**Proposed EV Mobility City with Ancillary Staff Quarters and
Talent Accommodation at Various Lots in D.D. 51 and
Adjoining Government Land, Fanling
(Application No. Y/FSS/20)
- Further Information No. 3 -**

In response to the departmental comments from relevant Government Departments, Further Information ("FI") No. 3 has been prepared. This FI submission consists of:

**S.12A Amendment of Plan Application
Proposed EV Mobility City with Ancillary Staff Quarters
and Talent Accommodation at Various Lots in D.D. 51 and
Adjoining Government Land, Fanling**

(Application No. Y/FSS/20)

Figure: 2.1

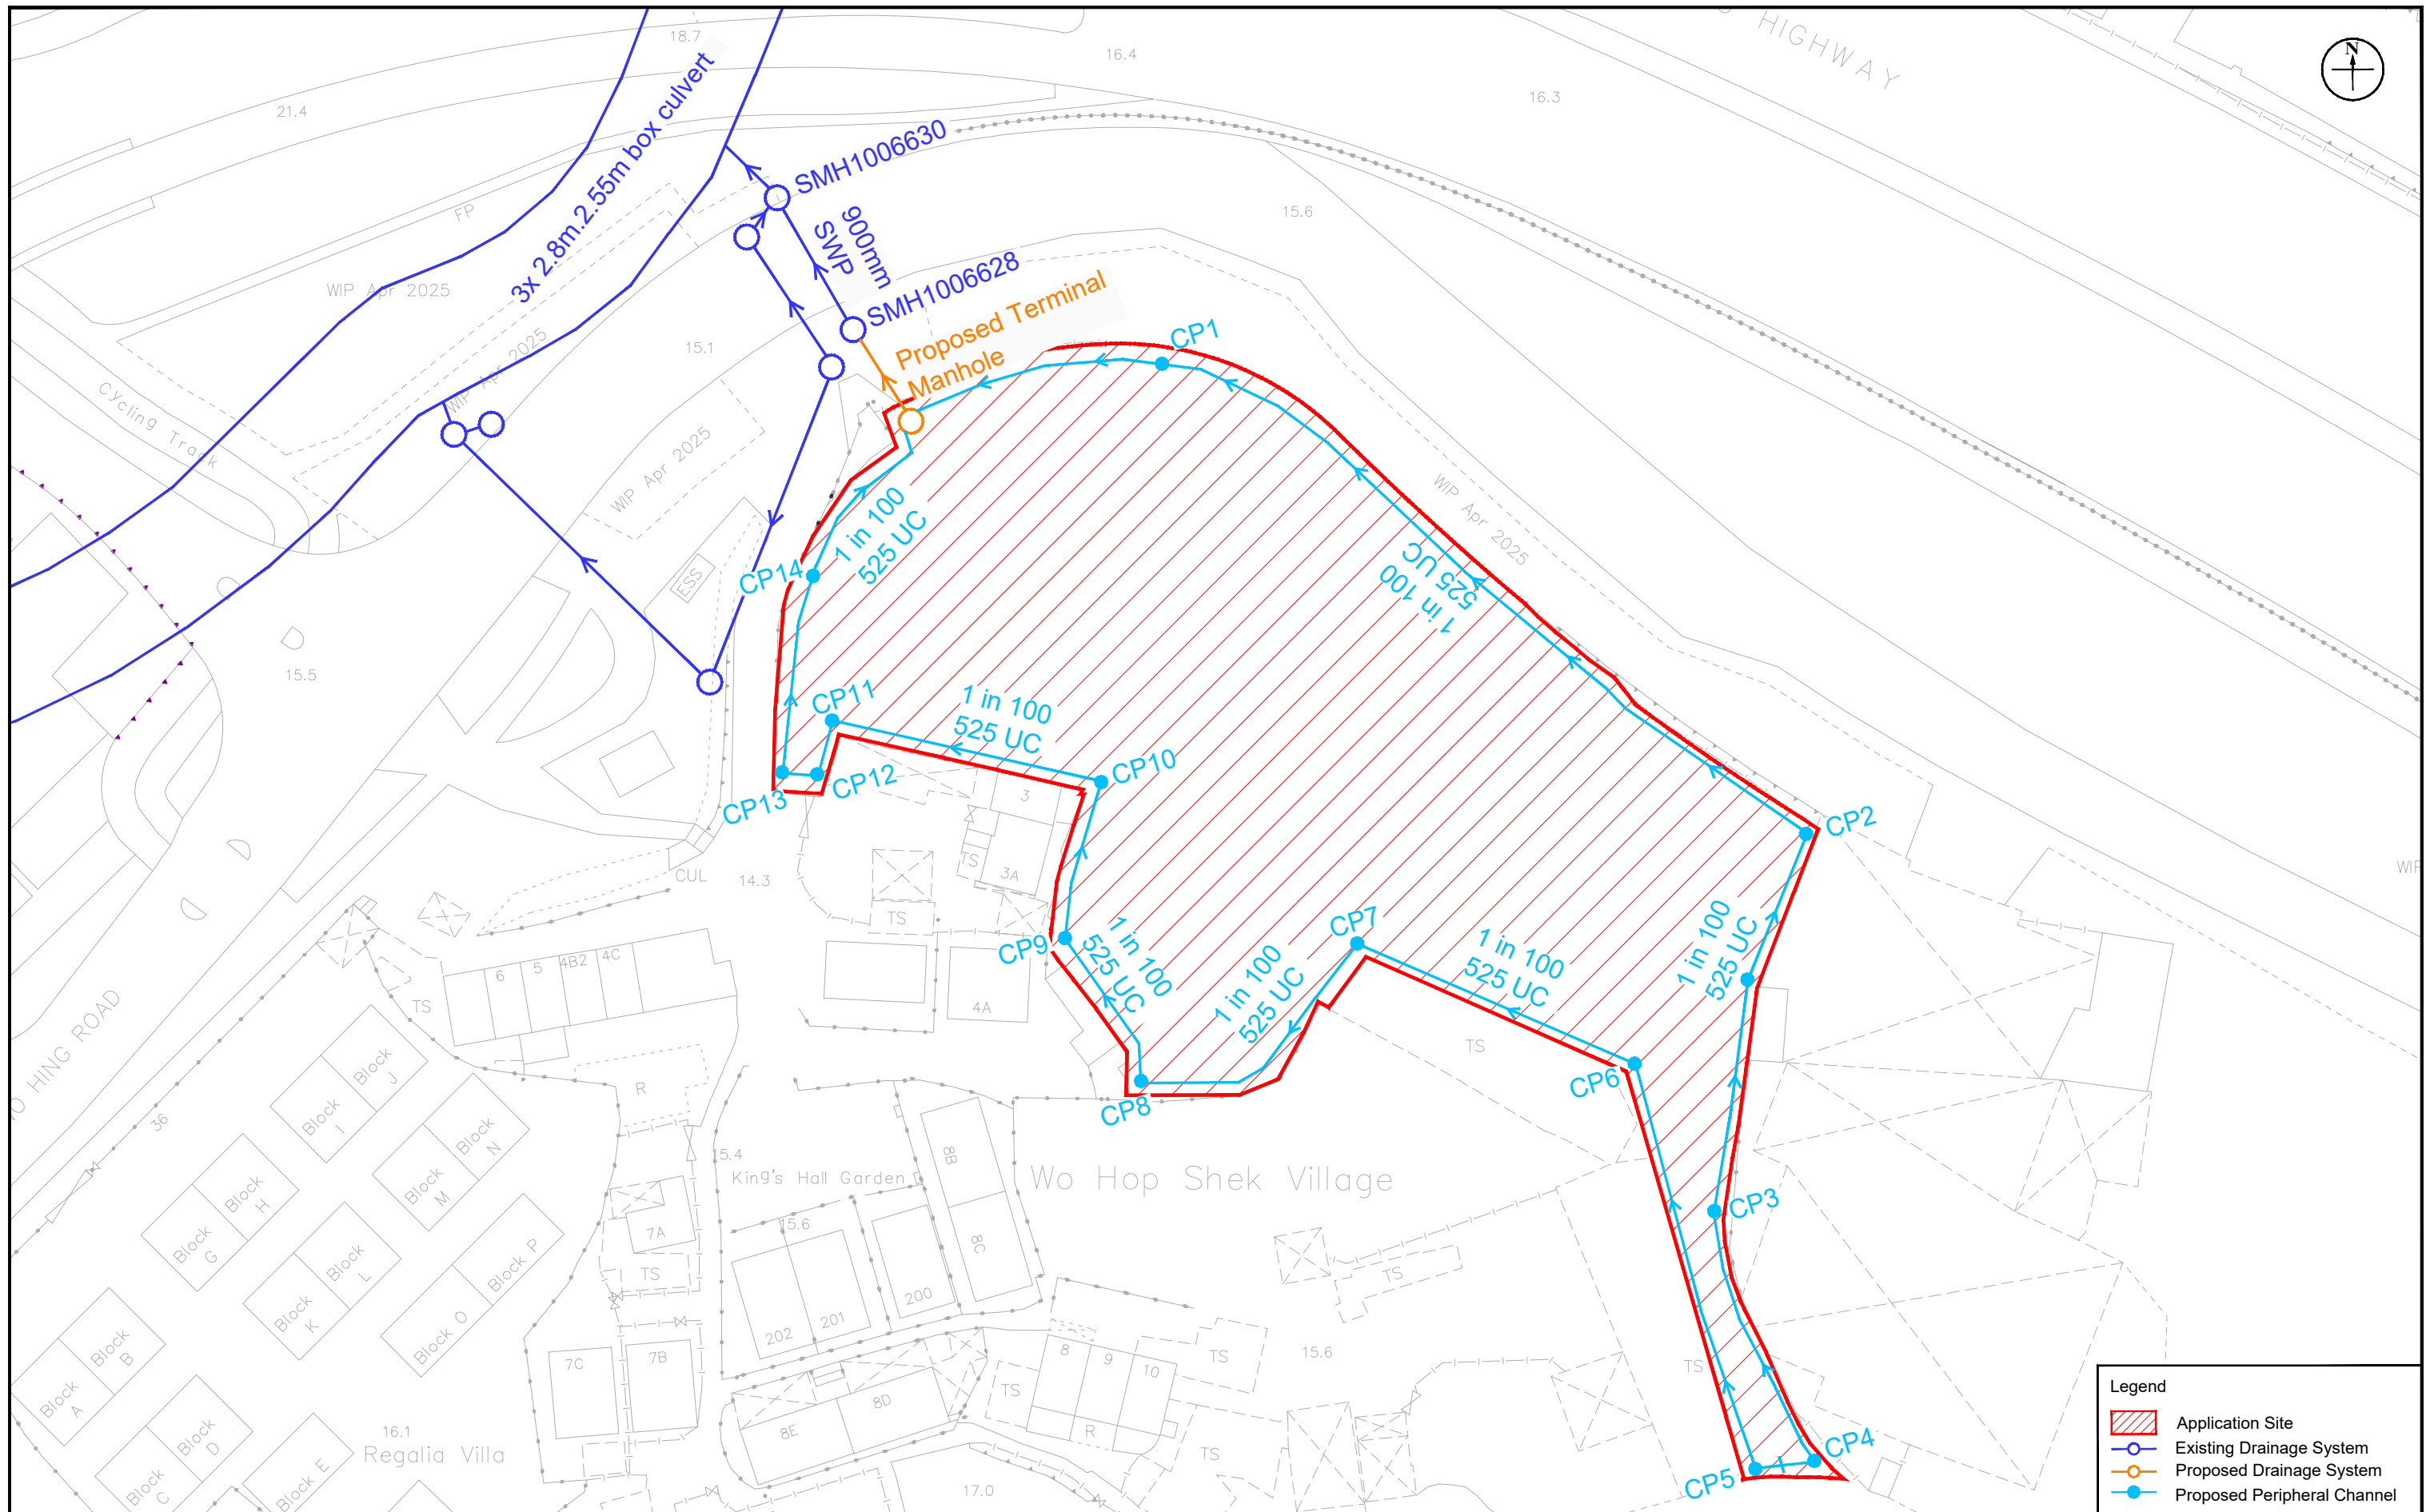
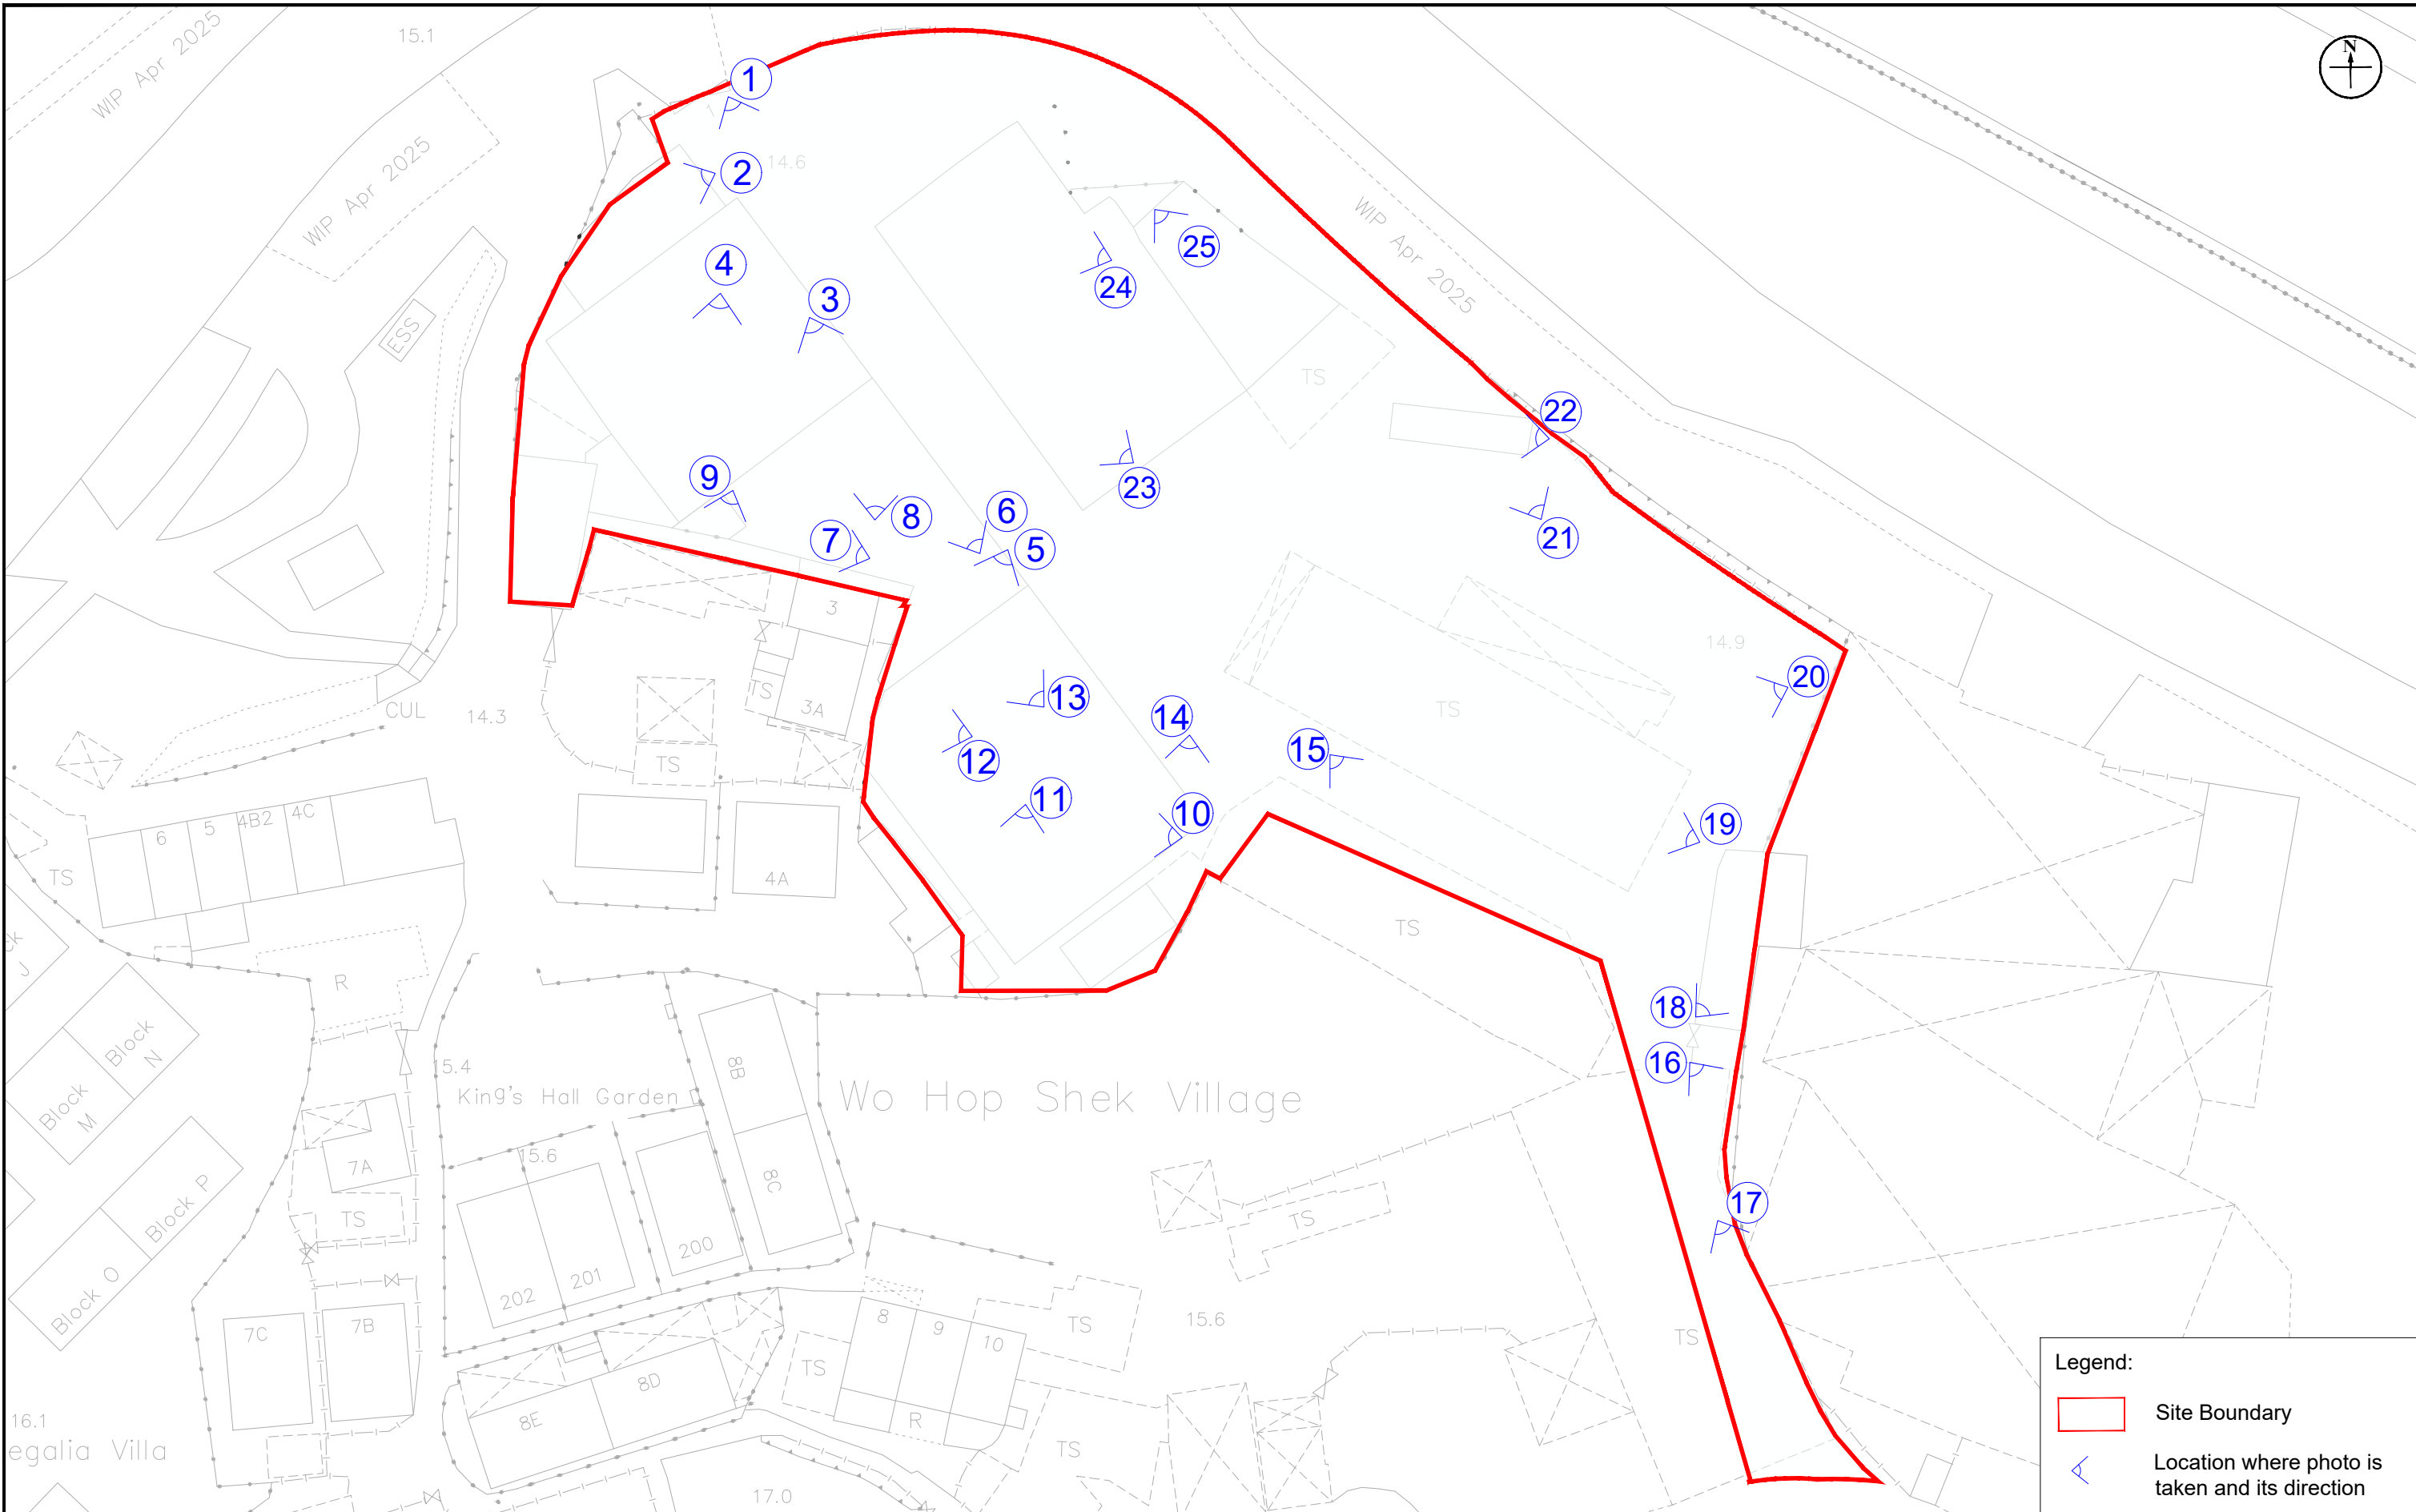
<p>2. The SIA report needs to meet the satisfaction of SIG/EPD, the planning authority of sewerage infrastructure.</p>	<p>Noted.</p>
<p><u>DIA</u></p>	
<p>1. Figure 2.1: Please also include the existing and proposed drainage system within the concerned site.</p>	<p>According to the site survey, there is no drainage system observed within the Application Site. The proposed terminal manhole and the proposed peripheral channel have been included in Figure 2.1.</p>
<p>2. Section 2.1: Please advise if there will be any filling of land. If yes, please assess if the filling of land may obstruct the existing overland flow from</p>	<p>The existing ground levels of the Application Site range from 14.6 to 14.9mPD. As per the layout plan, the ground level is set to be 14.75 mPD. Consequently, no land filling is required.</p>

- 2.1.1 The Application Site currently is paved with a partially green area and occupied by warehouses and open area. The Application Site is served by existing public drainage system. There is a Ø900mm drainage pipe (SWD1010692) at immediate northwest across Wo Hing Road to receive the runoff discharged from the Application Site and then connected to the existing 3 x 3.8m x 2.55m of box culvert (SBP1001912). The existing and proposed drainage system is indicated in **Figure 2.1**.
